Independent Urban Design Evidence

Prepared on behalf of City of Melbourne
Fishermans Bend Planning Review Panel

Prepared by
Koos de Keijzer
M.Arch, AIA

5.1 The proposed Fishermans Bend Planing Review Panel Draft Amendment GC81 Lorimer Precinct

Figure 1

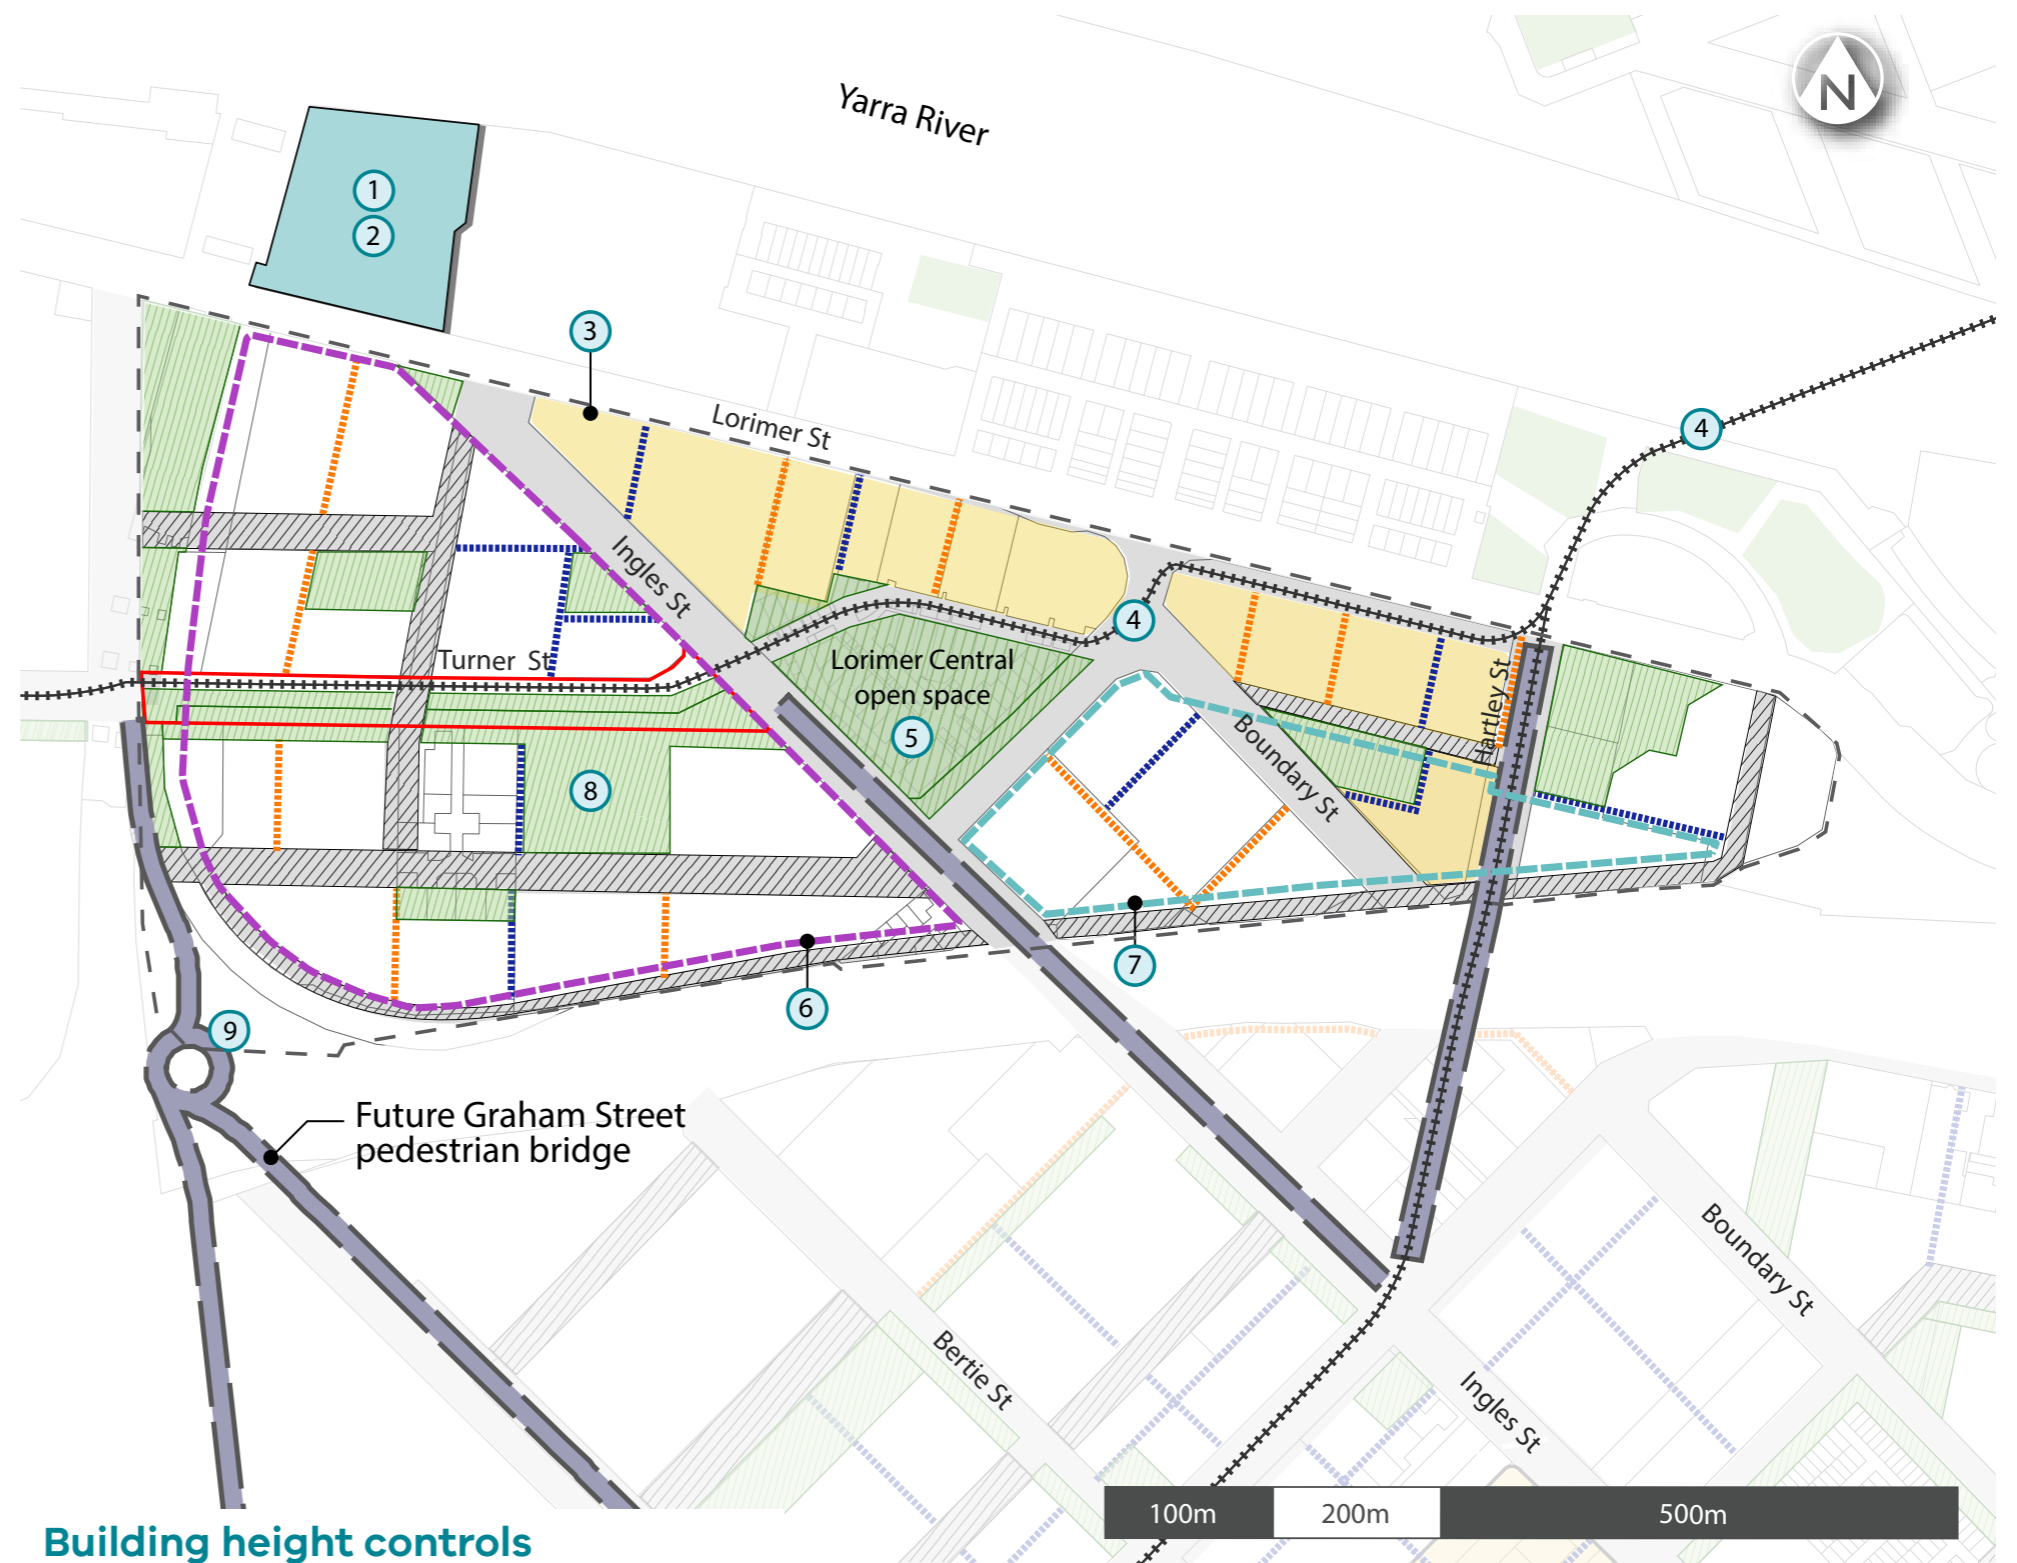
The Westgate Freeway interface - is an acoustically loud interface and visually an eye sore along the precinct. This interface is also at the South side of the precinct - meaning there is no sun blocking issues. If higher storey tolerances are required within the precinct they should reside along this interface, to both block noise and the existing eye sore.

The Lorimer Street Interface - is one of the most aesthetically pleasing due to its close proximity to the water. The interface is on the north of the site and consequently strict height restrictions should apply to avoid blocking sunlight to the rest of the Precinct. The interface experiences moderate-to-high wind due to the waterfront location, and this should be addressed in the design process.

The Turner Street Green Reserve - is positioned in the middle of the site and has the potential to be the heart of activity within the precinct, if urban planning is carefully approached. With the planned Public Open Space (P.O.S.) along this interface it is important that natural sunlight is protected to make Turner Street an interactive area for the community to enjoy.

Figure 3

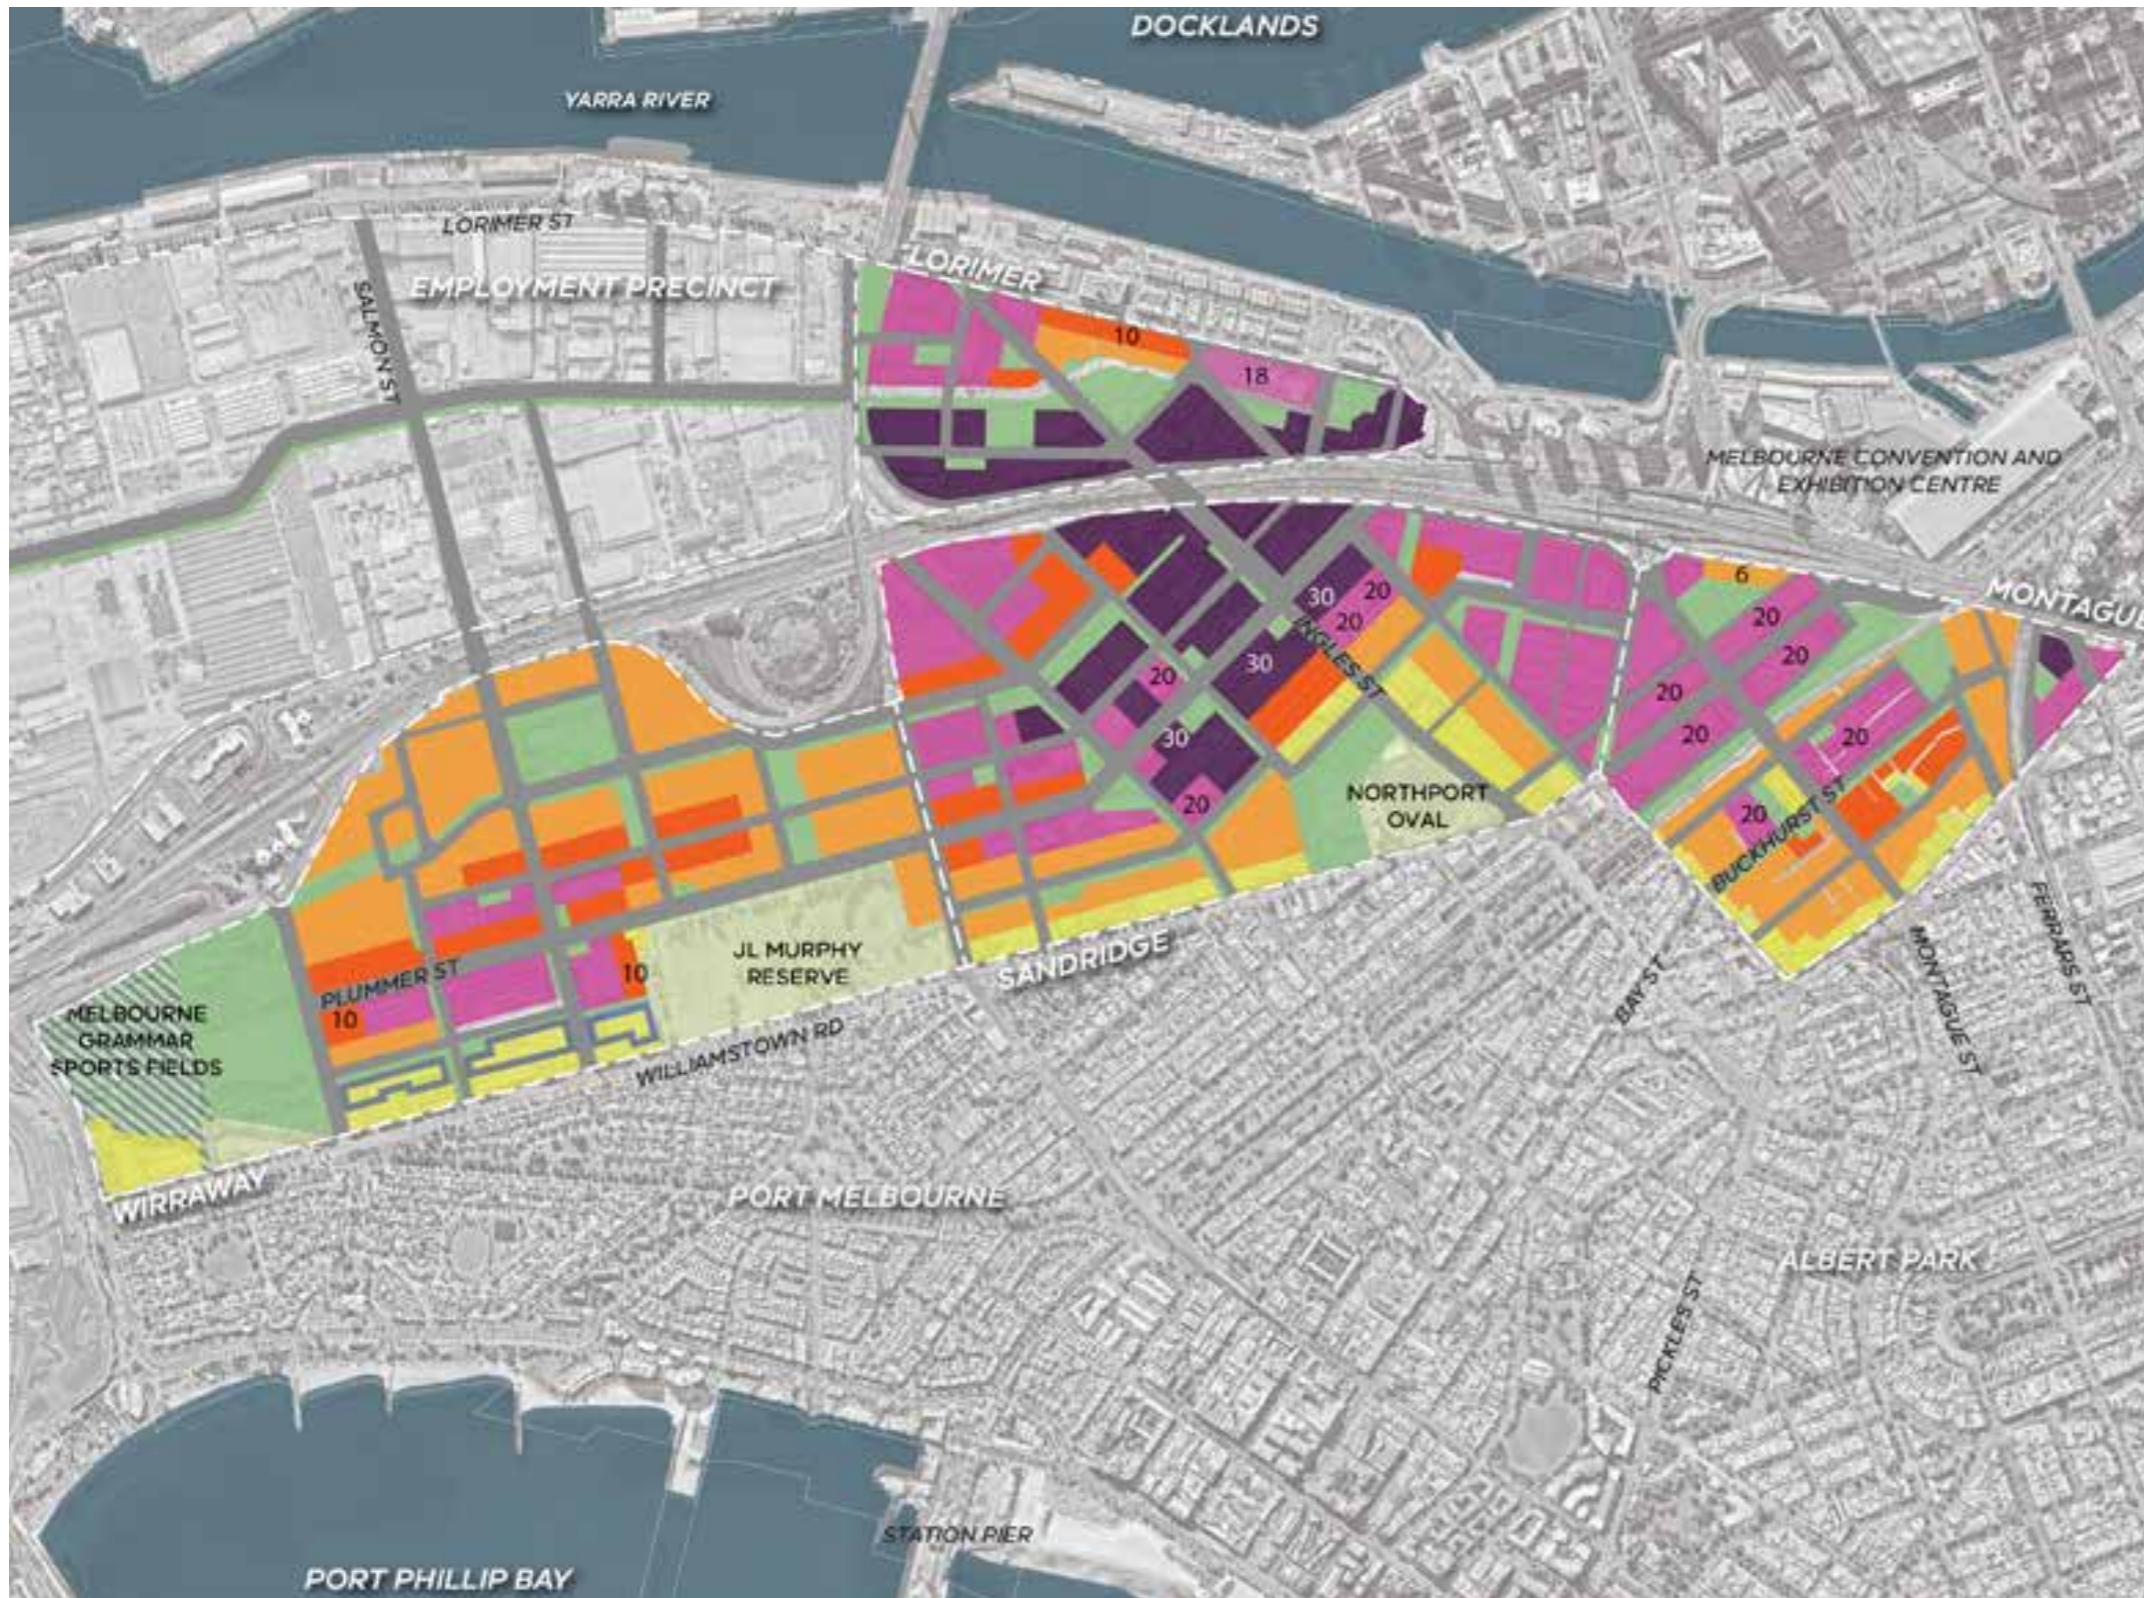
The unfortunate result of these strategies is more of a high rise South Bank. The height controls intended for Lorimer in my opinion are reasonable but add little to the concept of Lorimer being a world-leading example of inner city renewal. With some sites having the opportunity for multiple towers above podiums, building separation should be a mandatory control. I would suggest adopting the NSW ADG controls on building separation.

Figure 11

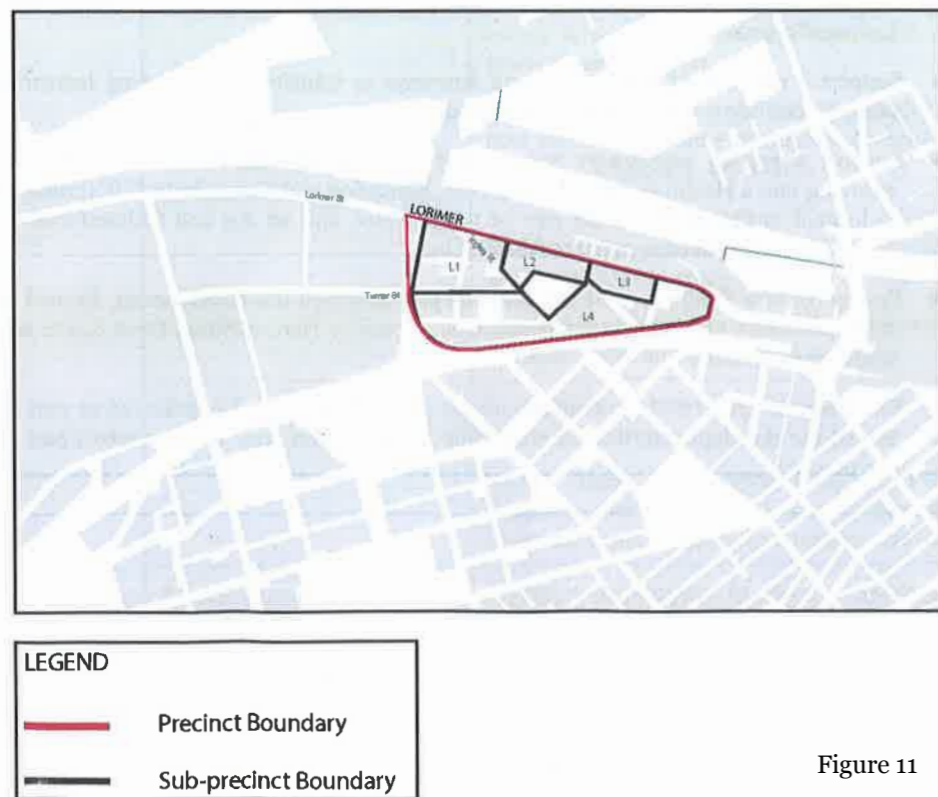
Another observation is the scale and detail of important planning maps, that are currently very small and almost illegible [figure 10 of clause 21.13.2] (see figure 11).

Figure 12

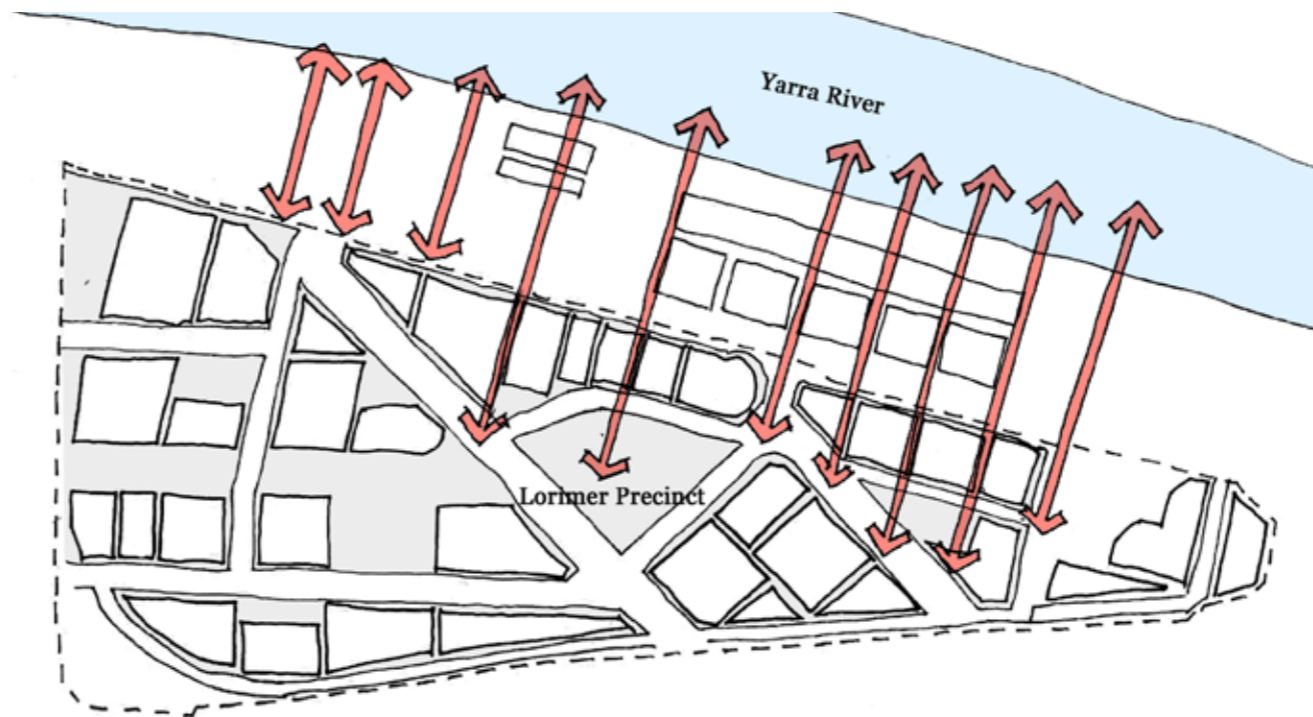
It is surprising that a greater emphasis of connectivity through Yarra's Edge to the Yarra has not been provided. Visual and physical connections could certainly decant some of the Yarra Rivers amenity into Lorimer Precinct. (see figure 12). It is surprising that in all the planning maps and overlays Yarra's Edge is shown as an amorphous mass. While acknowledging that Lorimer Street is an important transport route to the Port, it is still relevant to analyse the development north of Lorimer street to 'knit' it back into the Lorimer Precinct.
